CONVENTION
DATA SERVICES

DRAINAGE BASIN &
RAIN GARDEN
PLANTING PLANS

Re: Convention Data Services Headquarters Project

From: [Sharon Rooney](#)
To: [Jonathon Idman](#); "[Eliza Cox \(ECox@nutter.com\)](#)"
Cc: [Greg Siroonian](#); "[Jack Landers cauley \(JLANDERSCA@aol.com\)](#)"; [Jeffrey Ribeiro](#); [Sarah Korjeff](#); [Chloe Schaefer](#)
Subject: RE: Convention Data Services - Revised Landscape Plan
Date: Thursday, September 8, 2016 3:05:04 PM

RAIN GARDEN PLANTING PLAN
1"=20'-0"

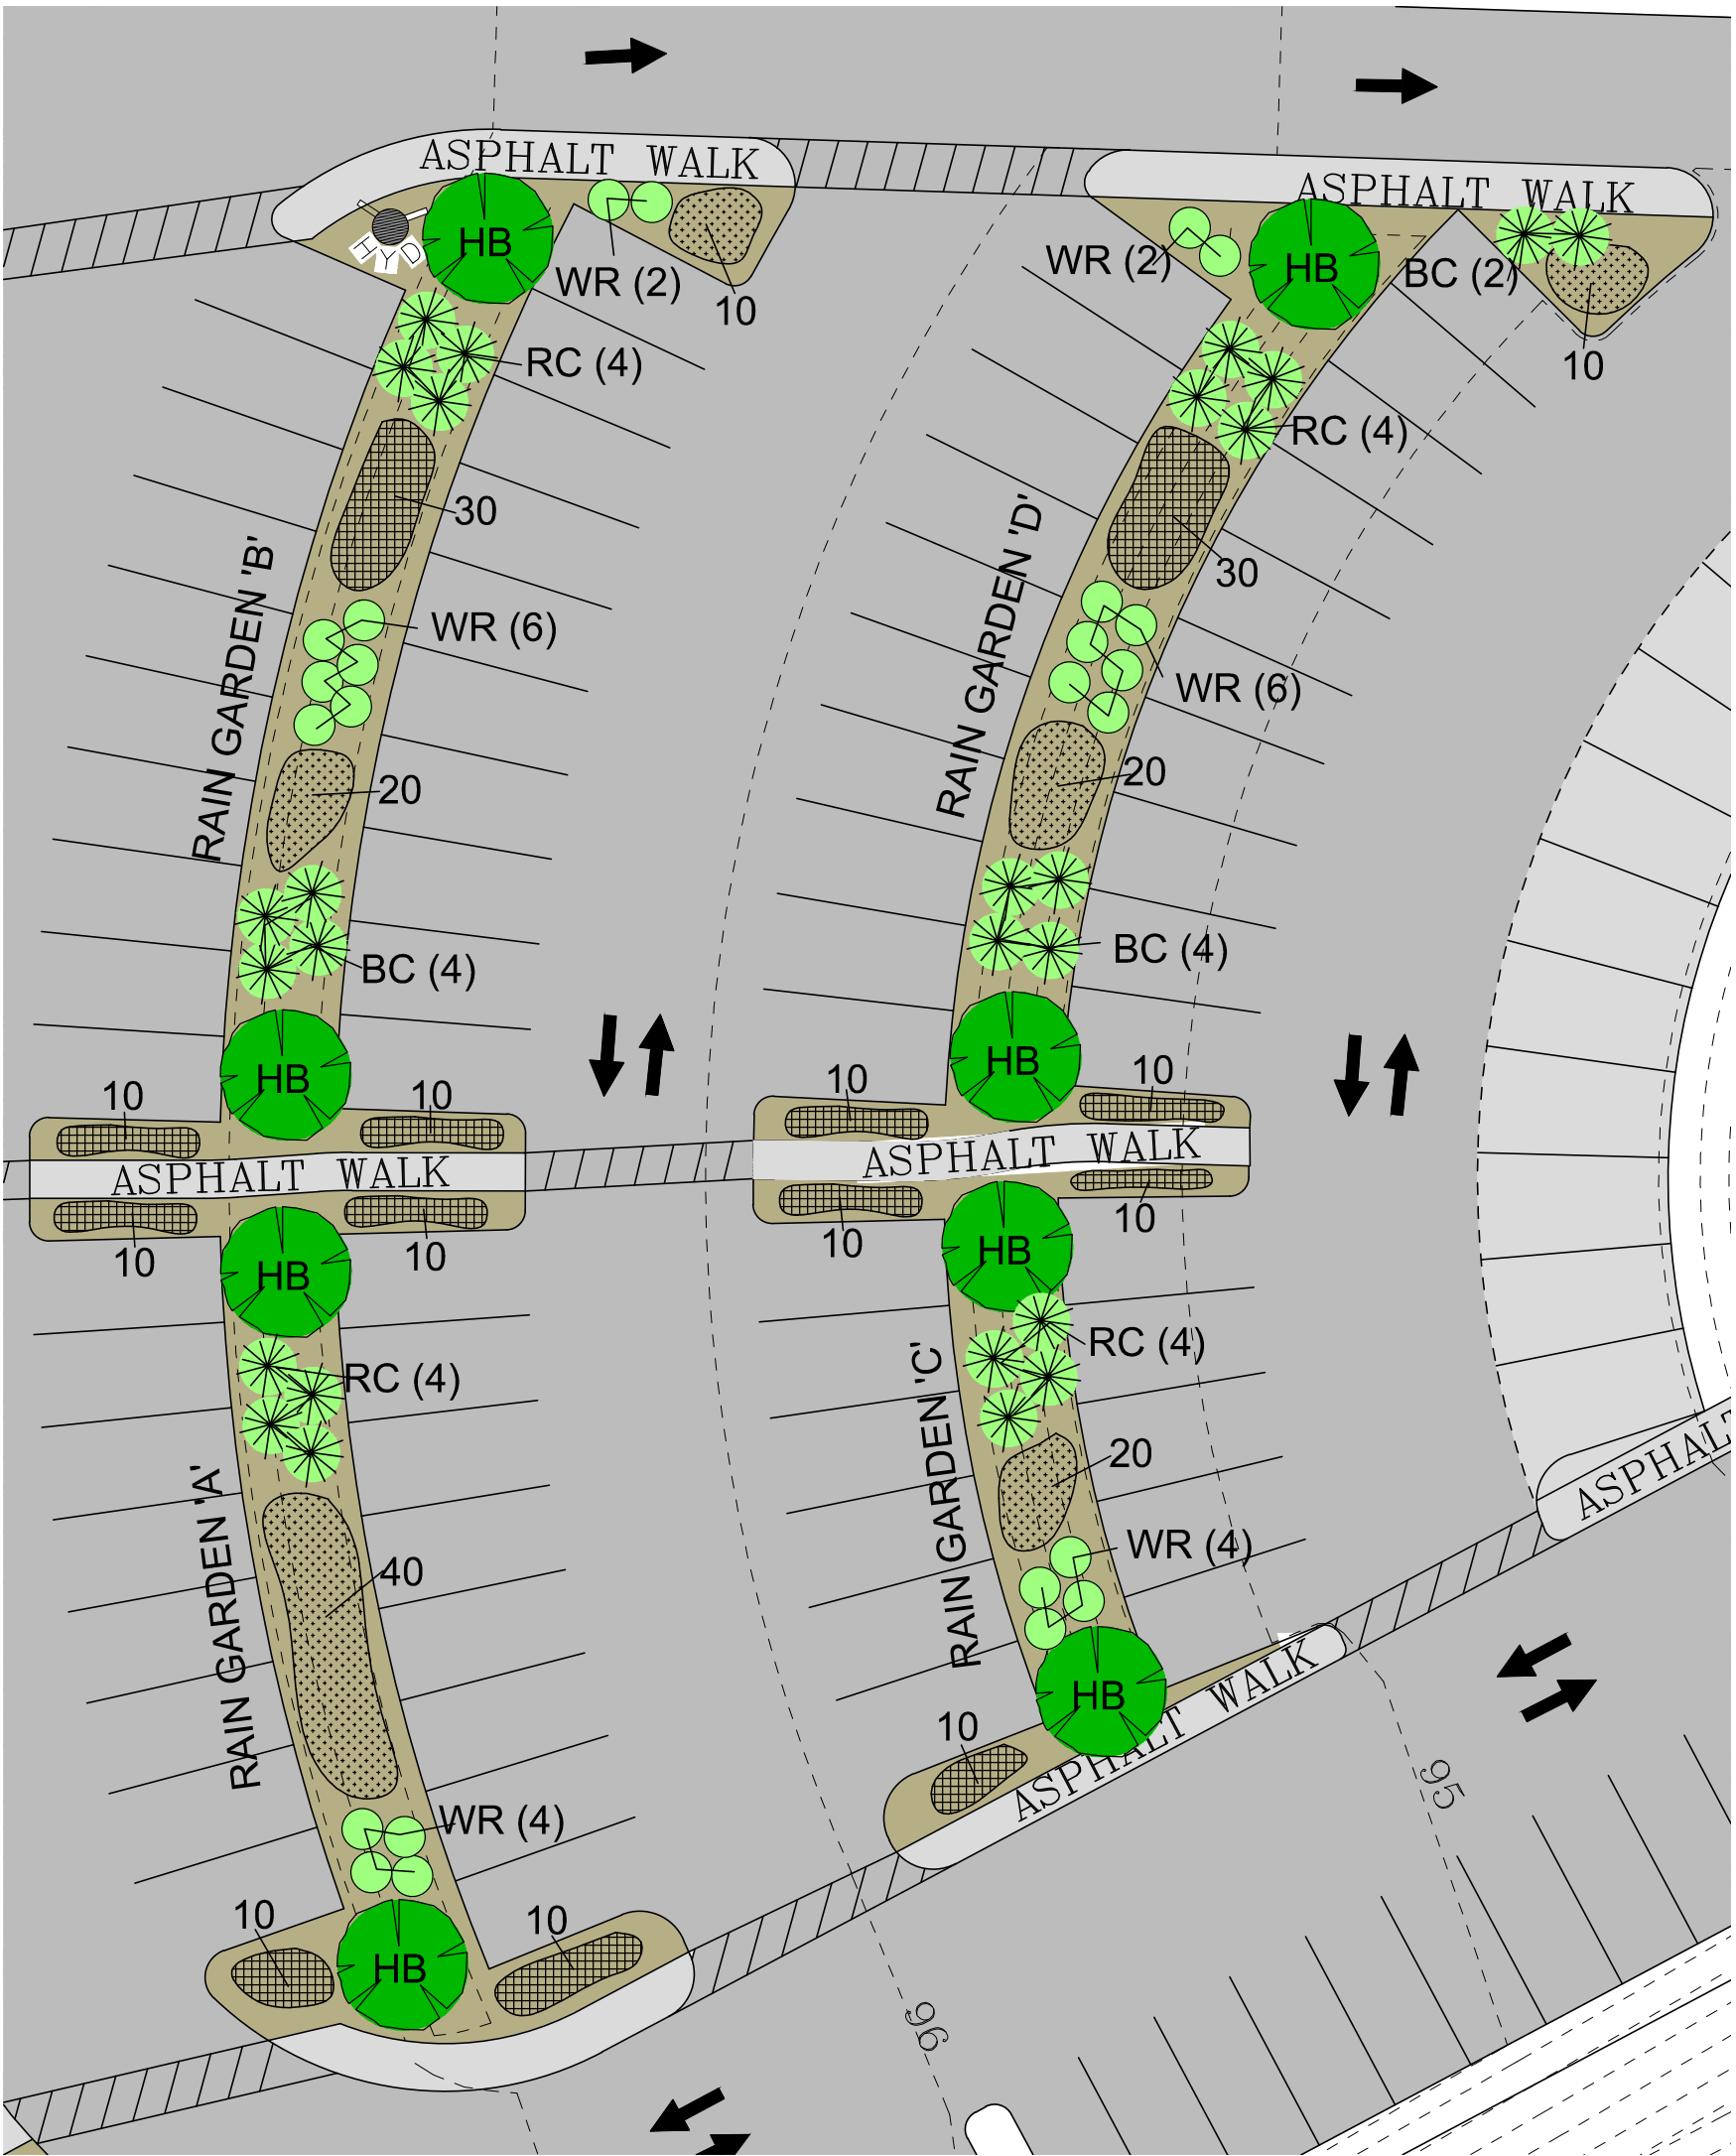
3.) Different and additional plantings are proposed in and around the rain gardens.

I just left a message for Greg that the revised landscape plan complies with the RPP standards. I appreciate the effort to address our concerns and the cooperation of the applicant in this regard.
